SUBMISSION - NORTHCONNEX

Engineer/Wahroonga Resident: Lin Ma

NorthConnex EIS Submission

NorthConnex Application Number: SSI 13_6136

Figure 9 Predicted tunnel traffic flows – northbound = 100 + 90 + 100 + 190 + 400 + 760 + 970 + 930 + 1080 + 1270 + 1240 + 1180 + 1150 + 1200 + 1360 + 1530 + 1610 + 1590 + 1080 + 610 + 450 + 370 + 260 = 19,500 VEHICLE/DAY

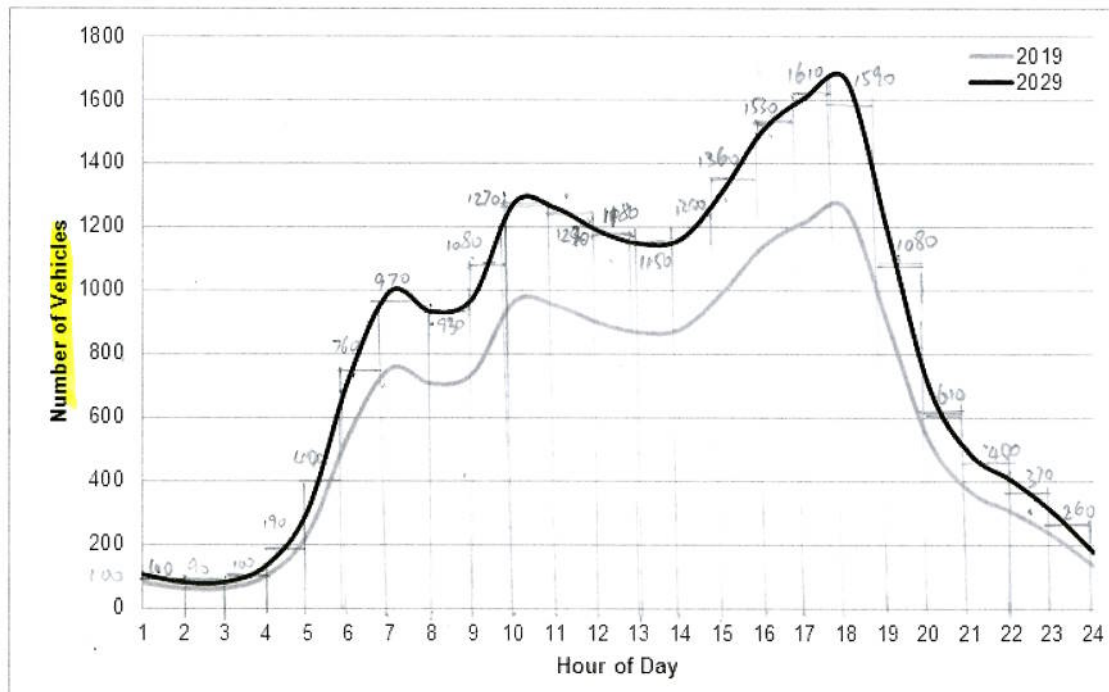
NorthConnex Project overview clearly states that the NorthConnex would take 5,000 trucks off Pennant Hills Road each day, and it would have capacity to carry more than 100,000 vehicles per day (50,000 in each direction). However the EIS emission calculation misleadingly used the figure of 19,500 vehicles per day per direction as the basis for their calculation. Refer to Appendix A for the handwritten calculations in relation to the EIS "Predicted tunnel traffic flow –northbound" in 2029.

In my professional opinion, the EIS vehicle emission has been underestimated by using the figure of 19,500 daily vehicles in lieu of 50,000 daily vehicles. Therefore, the purported EIS calculation is not only unreliable but raises the concern whether it accurately includes the "5,000 [daily] trucks off Pennant Hills Road".

NOTE: A SUMMARY OF UNDER SHADED AREA FOR 2029 = 19,500 VEHICLES/DAY
WHICH IS FAR LESS THAN THE TUNNEL CAPACITY 50,000 VEHICLE/DAY

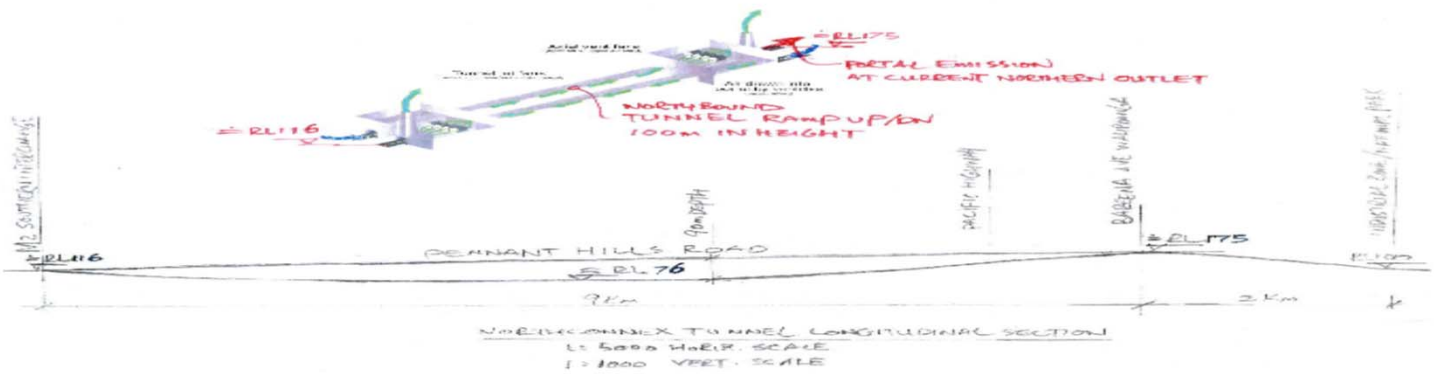
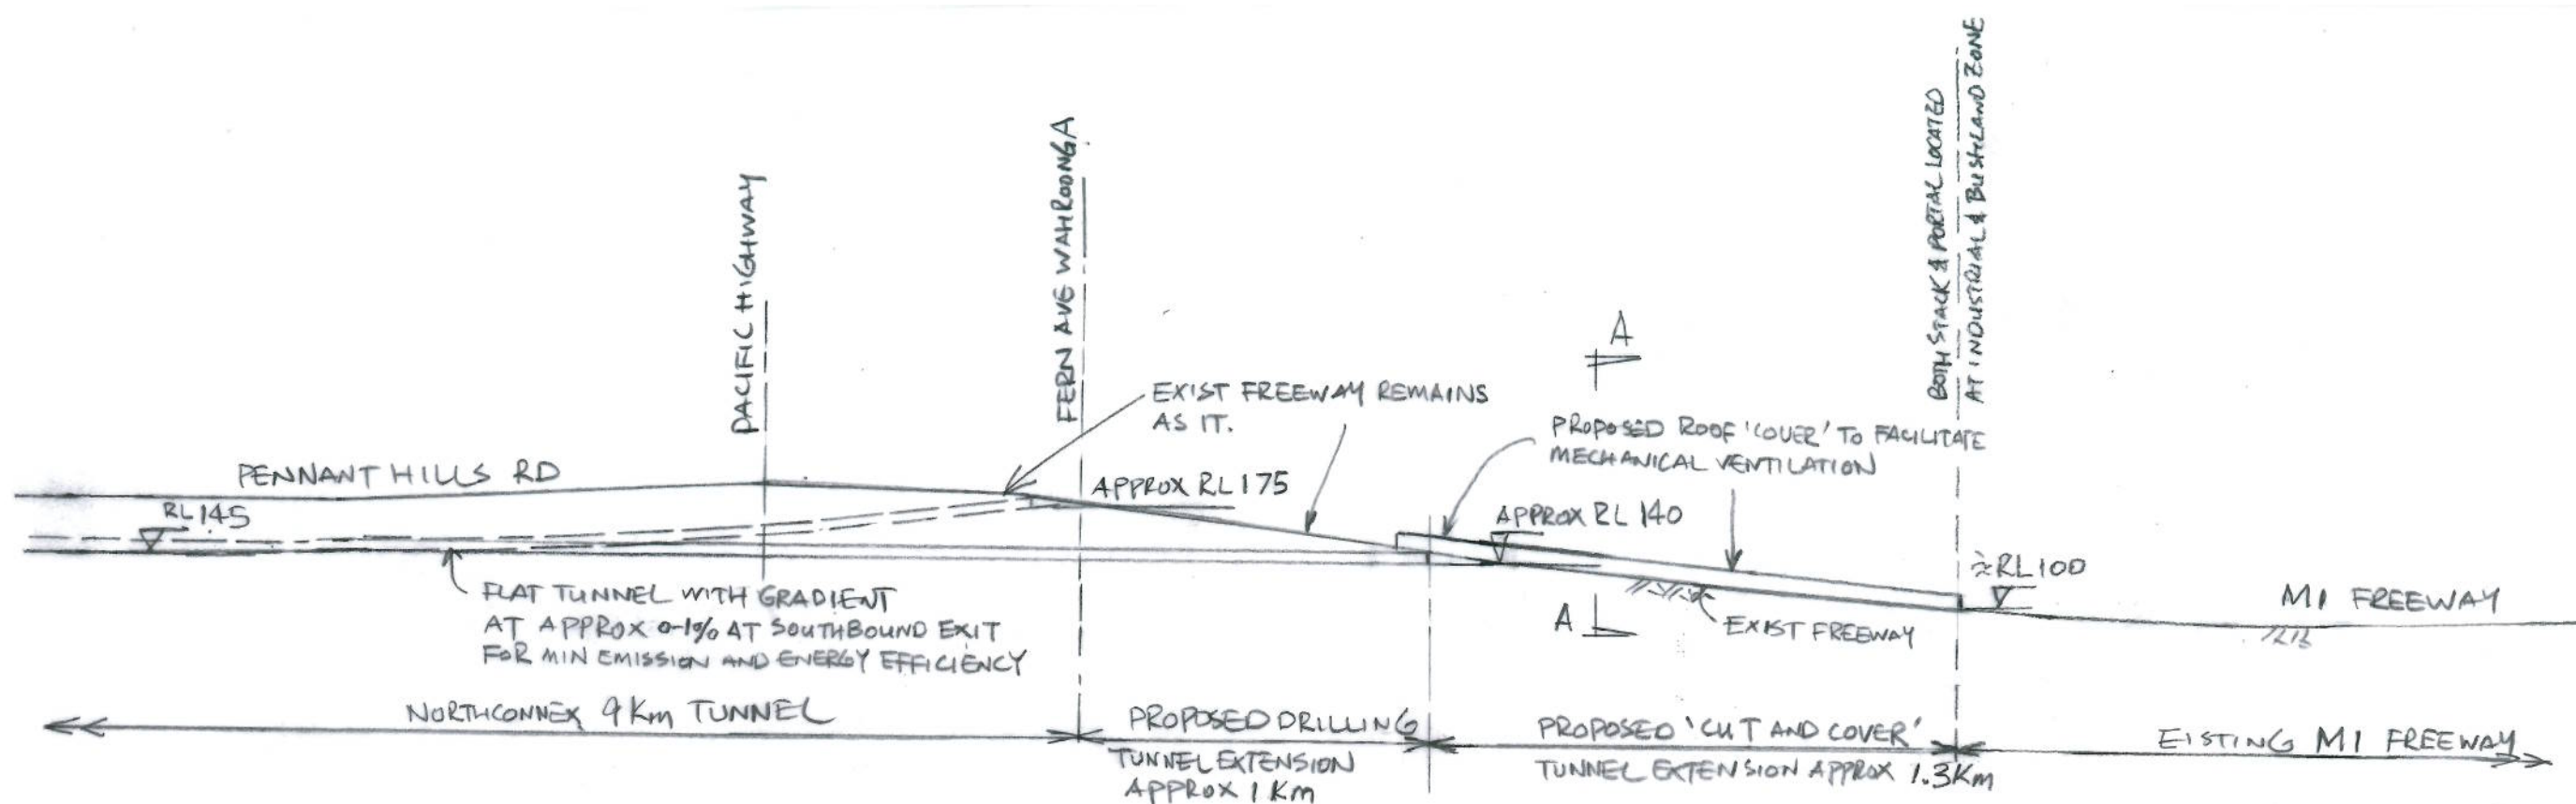
I am concerned about the project including future provisions for portal emissions in densely populated areas. In my professional opinion, the zero portal emission is technically impossible, I believe the portal emission is likely around 8% of total emission & unavoidable in reality e.g. M5 East Portals. Please refer to Appendix D- Simplified spreadsheet calculation for portal emission, which I have briefly summarized below:

- Vehicle emission within last 300m distance is equivalent to 3.33% of total 9km tunnel emission
- Average volume ratio drawn by vehicle/fan capacity is 4.6% at axial fan location 300m from portal; please notice the exit vehicles will also create a proportion of air release whining the negative pressure zone generated by fans.
- Total portal emission is likely around 8% of total tunnel emission

So total estimated Portal Emission = A + B = 3.33% + 4.6% = 8% approx

SECTION 'A-A'
AT 'CUT & COVER' TUNNEL 1:200

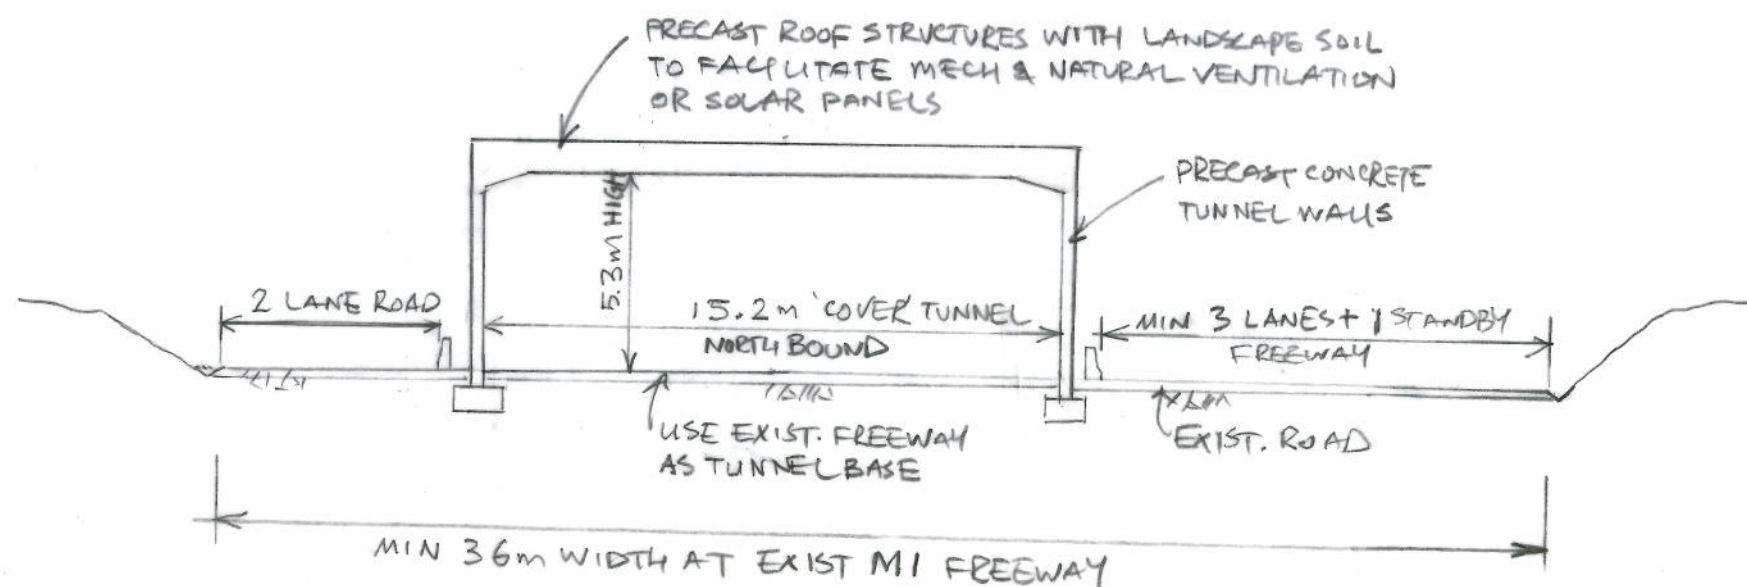
Importantly, I would like to propose an alternative 'cut & cover' tunnel extension & relocate Northbound portal & stack into bush land & industrial zone, please find the attached "Appendix E- Alternative 'Cut & Cover' Tunnel" design sketch for your consideration. I have briefly listed some advantages of my alternate design below:

- Flat tunnel to minimize emission & increase energy efficiency which ought to be in the NorthConnex first instance. Therefore I propose the last portion of Northbound tunnel to be as flat as possible to avoid any vertical bend in the transition zone between the driving & 'cut & cover' tunnels. This has should be a lesson learnt from the design mistakes in the M5 Tunnels.

- Use the 'cut & cover' concept to further extend Northbound portal & stack into industrial & bush land zone.
- Basically use existing freeway as a tunnel base & build walls/roof 'cover' to facilitate mechanical ventilation or rooftop for landscape/solar energy.

- Existing freeway at North Wahroonga has sufficient minimum 36m width to accommodate the 'cut & cover' tunnel in the middle of aisle as shown on section A-A, and provide advantage to access tunnel at side walls for all fire emergence(EIS does not consider currently).

- The precast walls & roof structures could be 1/4 cost of drilling tunnel per km, the structural cost of 1.3km 'cut & cover' tunnel could be about \$50million, which provides budget allowance to keep all Northbound portal/stack away from residential zone.
